Docket Nos. 50-259, 50-260  
and 50-296

SUMMARY REVIEW OF FISH IMPINGEMENT  
AT THE BROWNS FERRY NUCLEAR PLANT  
SEPTEMBER 1976 - AUGUST 1979

The current action has resulted in the staff's recommendation to revise ETS Section 4.1.2(f), entitled "Fish Impingement on Intake Screens". Suggested wording for the revisions are provided on the following page which would replace page 17 of the existing ETS for each of the three units of the Browns Ferry Nuclear Plant. The location of revisions is indicated by the vertical bars on the right margin of the page.

Figure 1. Variation in impingement at Browns Ferry Nuclear Plant by species group (monthly contribution to impingement for each study year).

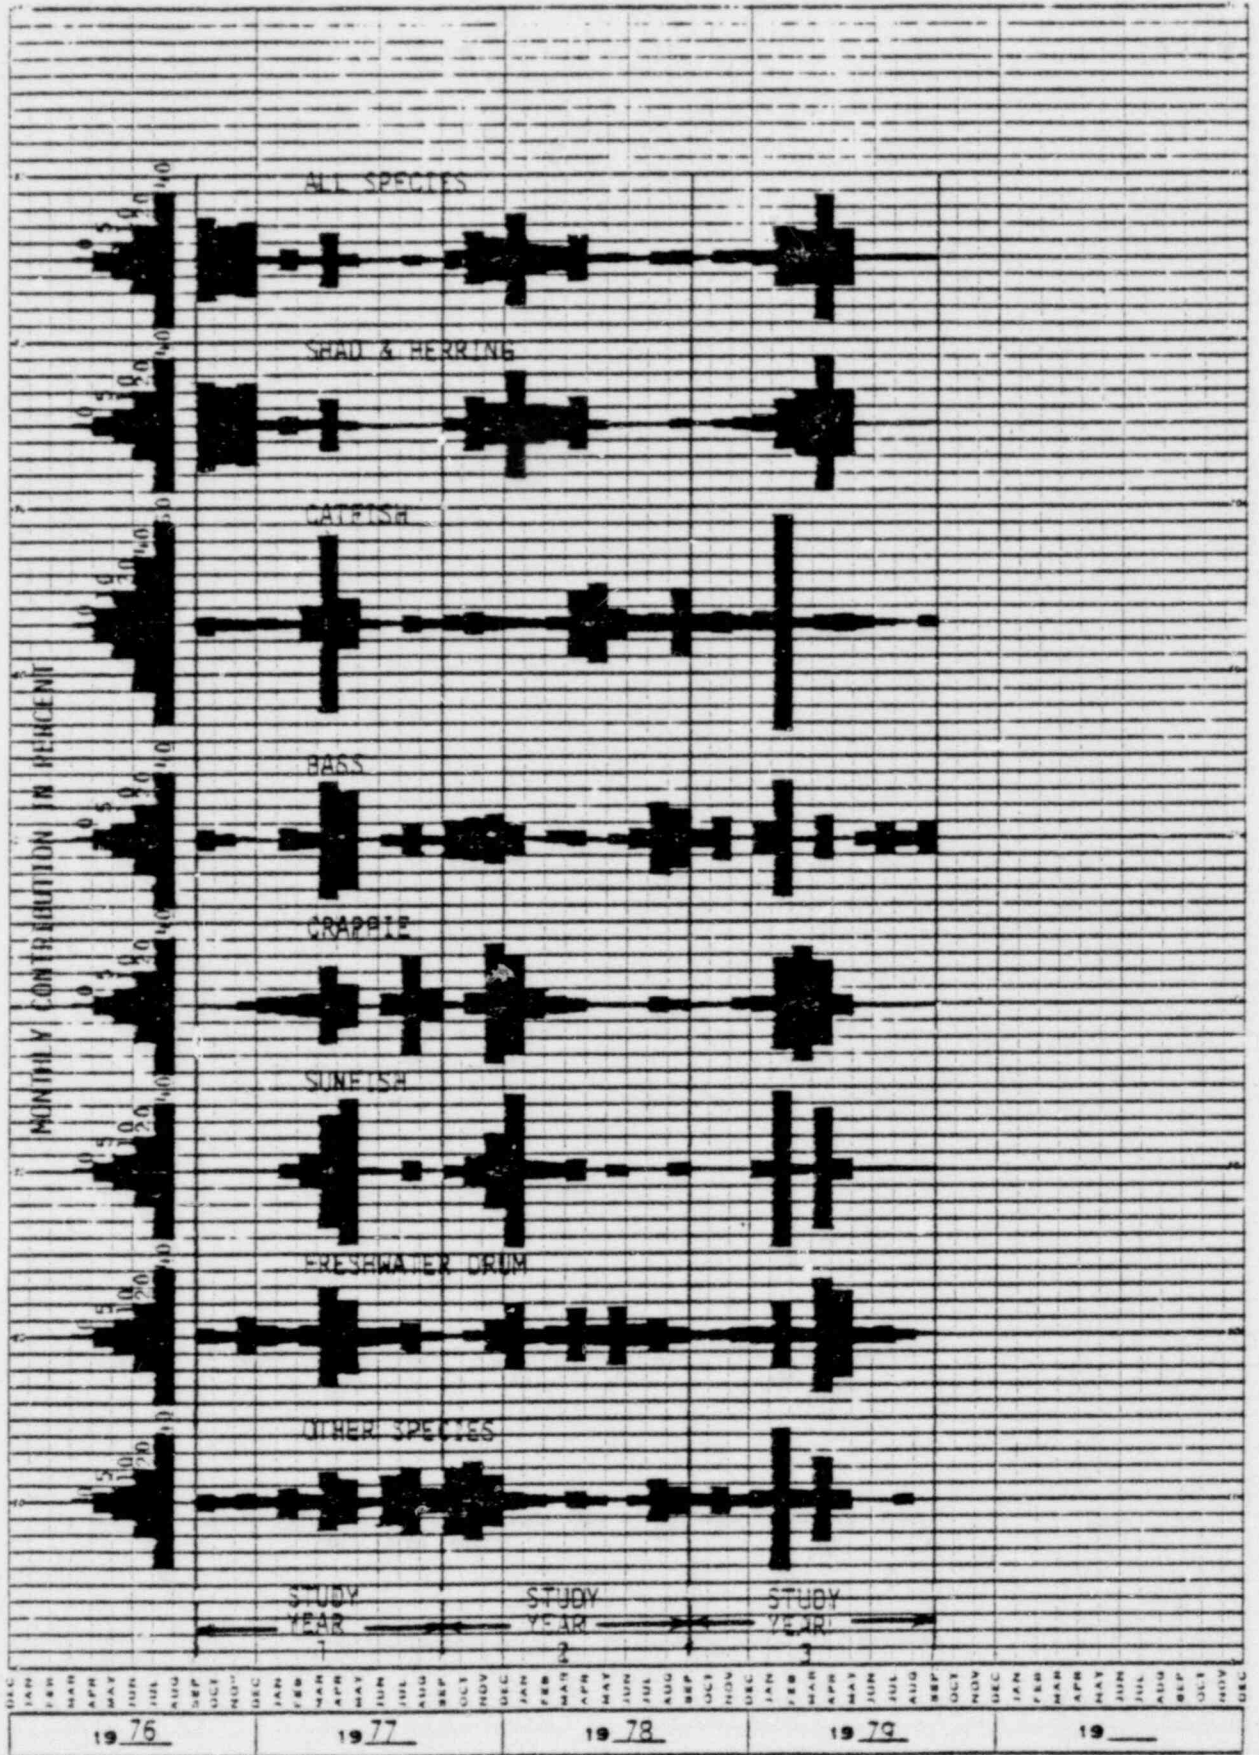
The monthly estimates (Table 2) show the major impingement of Clupeids occurring over the three months, September through November. Figure 1 illustrates the relative contribution of monthly impingement to the 12-month totals for each of the three "study years". TVA has noted that, for this study period, peak impingement of clupeids occurred earlier than had been observed during the prior years of plant operation (ibid, p. 14). We found this early peak in the Fall of 1976 to be an exception from those observed in Study Years 2 and 3, also.

Monthly estimates of impingement (Table 3 and Figure 1) show the major peak for clupeids to have occurred in December, with relatively high monthly values starting in October 1977 and continuing through March 1978.

Monthly estimates of impingement (Table 4 and Figure 1) show the major peak for impingement of clupeids to have occurred in March with relatively high impingement values spread over the 4-month period January through April 1979. Compared to the previous two 12-month periods, the peak impingement of clupeids in March was about three months and six months later than that observed in "Study Year 2" and "Study Year 1", respectively. Total estimated numbers of clupeids impinged during "Study Year 3" were about one million less than during the second period and about four million less than during the first period. This reduction in
